Planning Sub Committee 06 March 2023

UPDATE FOR CONSIDERATION AT PLANNING SUB-COMMITTEE Item No.1

Reference No: HGY/2022/3858	Ward: Hornsey
Address: Wat Tyler House, Boyton Road, Hornsey, London, N8 7AU	
Proposal: Redevelopment of the car park adjacent to Wat Tyler House to provide 15 new Council rent homes in a part 4, 5 and 7 storey building. Provision of associated amenity space, cycle and refuse/recycling stores, a wheelchair parking space on Boyton Road and enhancement of existing communal areas and play space to the rear on the Campsbourne Estate.

UPDATE FOR CONSIDERATION AT PLANNING SUB-COMMITTEE Item No.9

Appendix 3 is amended to include revised ground floor plan, which would supersede KCA-0535-1100 Revision M.

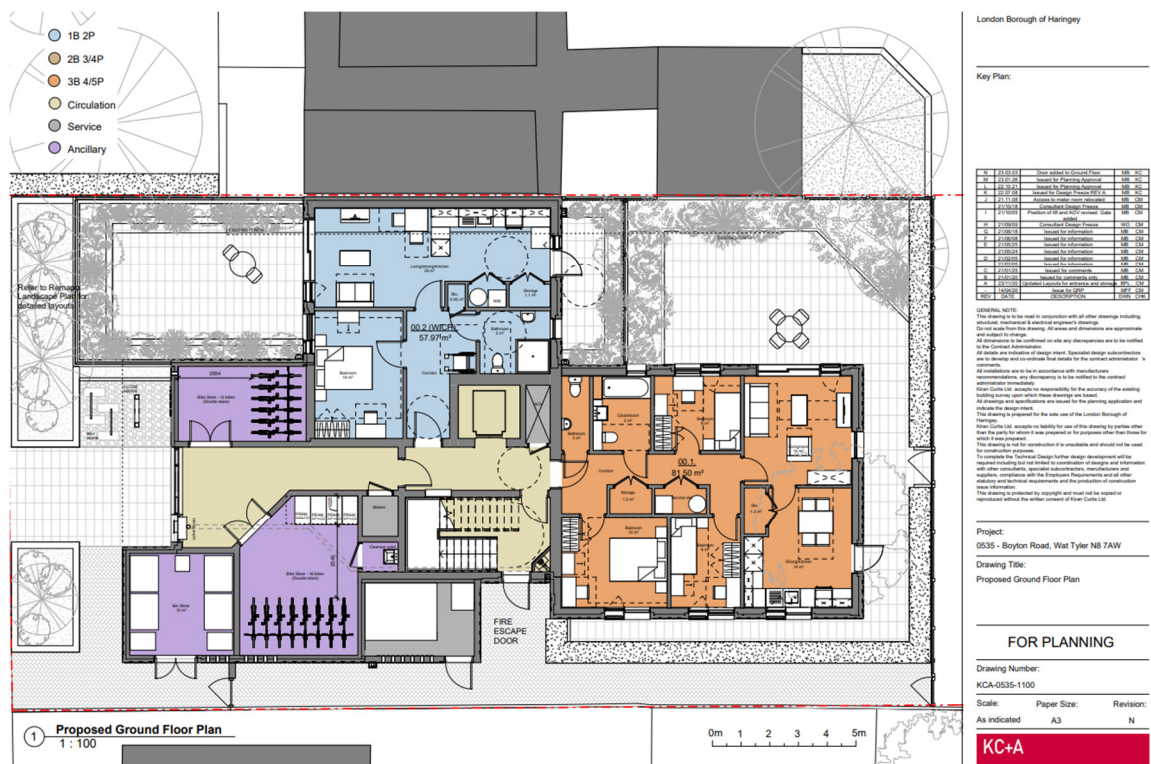
2. The approved plans comprise drawing nos: KCA-0535-0001 Revision K, KCA-0535-0003 Revision G, PL_0300, PL_0301, PL_0302, KCA-0535-1000 Revision I, KCA-0535-1100 Revision ~~M~~ **N**, KCA-0535-1101 Revision G, KCA-0535-1102 Revision G, KCA-0535-1103 Revision G, KCA-0535-1104 Revision G, KCA-0535-1105 Revision F, KCA-0535-1106 Revision G, KCA-0535-1107 Revision H, KCA-0535-2000 Revision E, KCA-0535-2001 Revision C, KCA-0535-3000 Revision G, KCA-0535-3001 Revision H, KCA-0535-3002 Revision H, KCA-0535-3003 Revision G, Arbtech AIA 01, Arbtech TCP 02, Arbtech TPP 01, 2.02, 5641_A_02 and 5641_A_03.

Proposed 1st floor

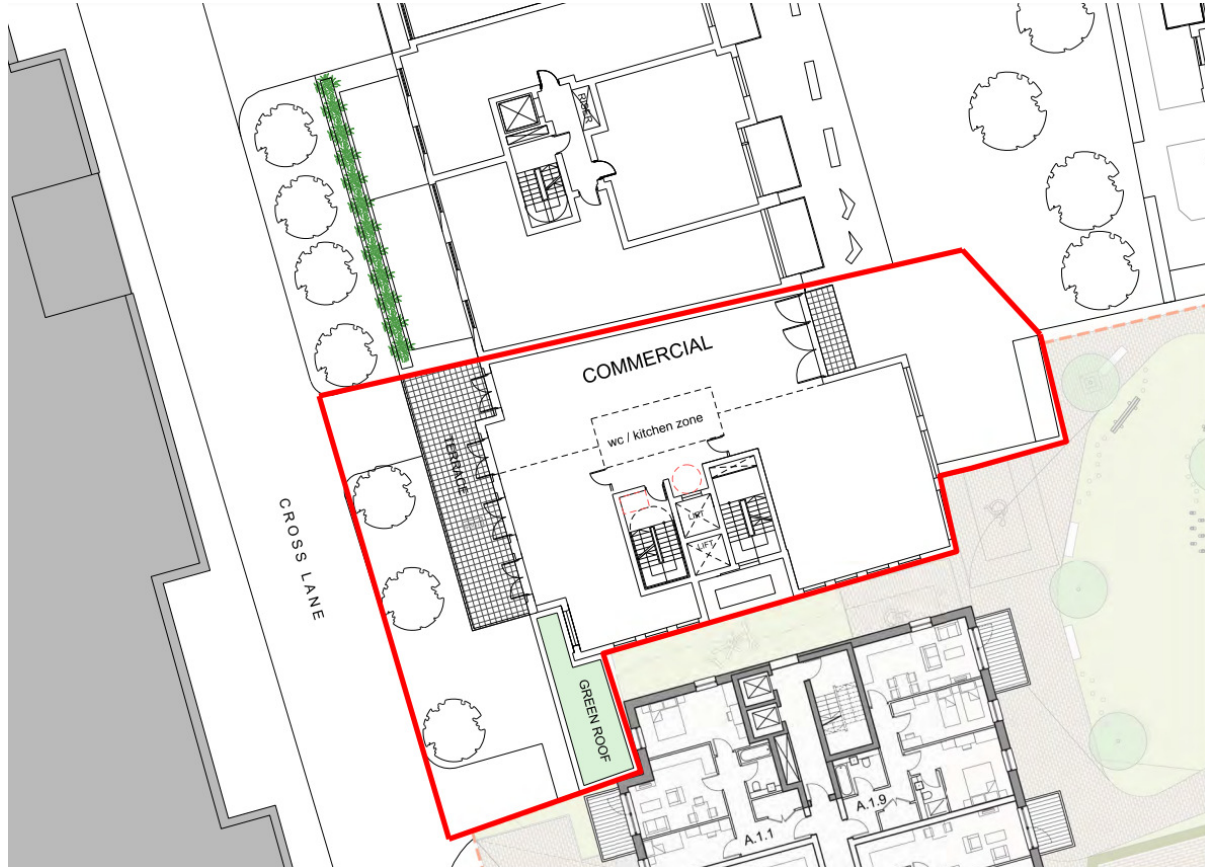
- Disruption from the car park entrance to local residents
- The first floor terrace is not set back or screened like Granita Courts terrace
- Noise and disturbance from the first floor terrace in a residential area

- Concerns the commercial units will have balconies
- Access to the terrace of the commercial property should be restricted
- The terrace should be redesigned

NEIGHBOURING PROPERTIES		
1 further letter received	- Disruption from the car park entrance to local residents - The first floor terrace is not set back or screened like Granita Courts terrace - Noise and disturbance from the first floor terrace in a residential area - Access to the terrace of the commercial property should be restricted - The terrace should be redesigned	The proposal will not result in any greater disruption from the car park than should be expected in an urban area. The 1st floor terrace would not result in a significant increase in overlooking to neighbouring properties The proposal will not result in any greater noise or disturbance from the first floor terrace than the current situation. The first floor terrace would not have a significant impact on neighbouring properties The design of the first floor terrace is considered appropriate
